TECHNICAL REPORT

Selection of the correct rocker
cover gasket for 14P, 15P &
TD5 engines for Land Rover

In the following images, both references are shown, indicating the **main differences between them**.

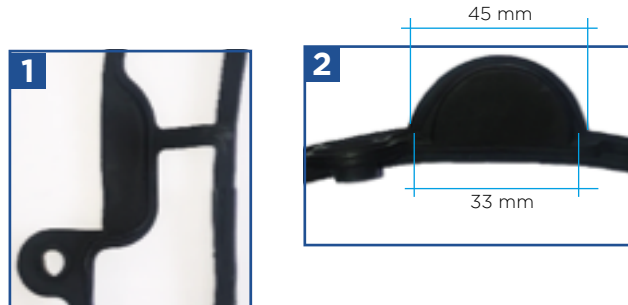
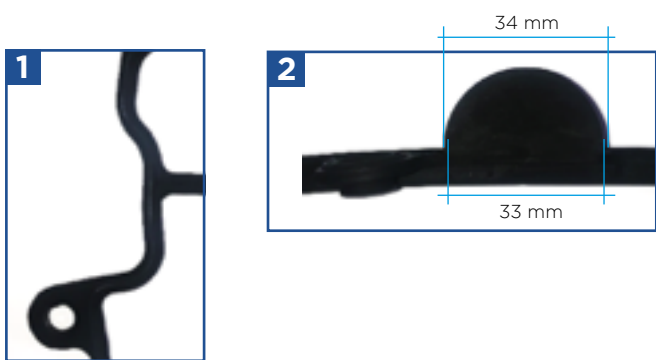
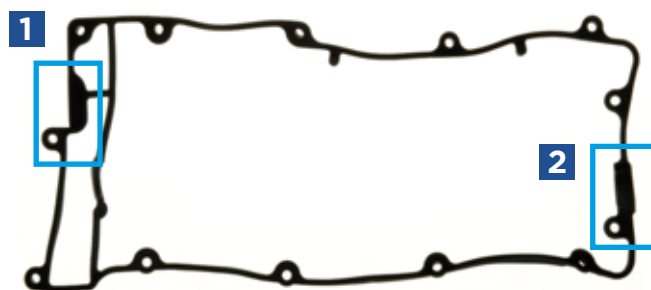
The main difference between them is the **profile** and one shape form at the end of the gasket. Therefore, Ajusa has both references **differentiated by the engine number**.

It is common to have lack of knowledge about the engine number which the vehicle belongs, so the objective of this tip is to **help our customers to be able to select the correct reference** based on the old one which was removed.

On the other hand, another possibility of identification is **by the VIN number of the vehicle** in the last 6 digits. In this case, these digits indicate the **sequence of the production line** of the vehicle which indicates the engine number.

LAST 6 DIGITS OF VIN	REFERENCE	GASKET SHAPE
XXXXXXXX ≤ 622423	11096500	
XXXXXXXX > 622423	11096600
